# **MEMORANDUM**

Site Plan Review

820070020

Poplar Run (aka Indian Spring)

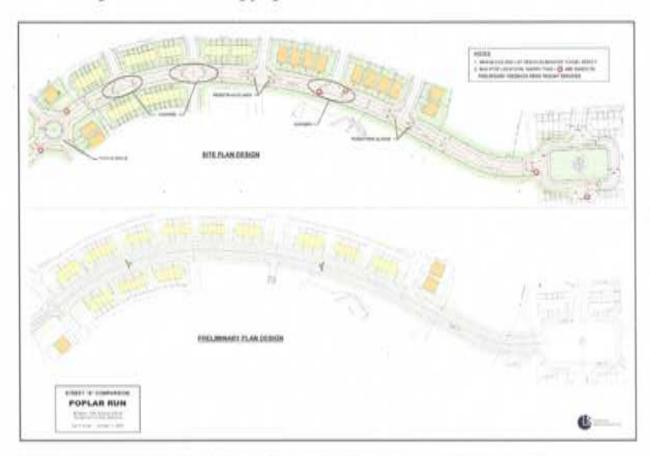
The Applicant has modified the road sections based upon comments by the Tivoli community, DPS, DPWT and Staff during the site plan process. The stated purpose is to deter non-local traffic while enhancing pedestrian safety and circulation is satisfied with the proposed modifications. The majority of the modifications are located within the public right-of-way for Street A, Tivoli Lane and Tivoli Lake Boulevard.

As shown above and on the following page, modifications have been incorporated into the design of the road sections throughout the community:
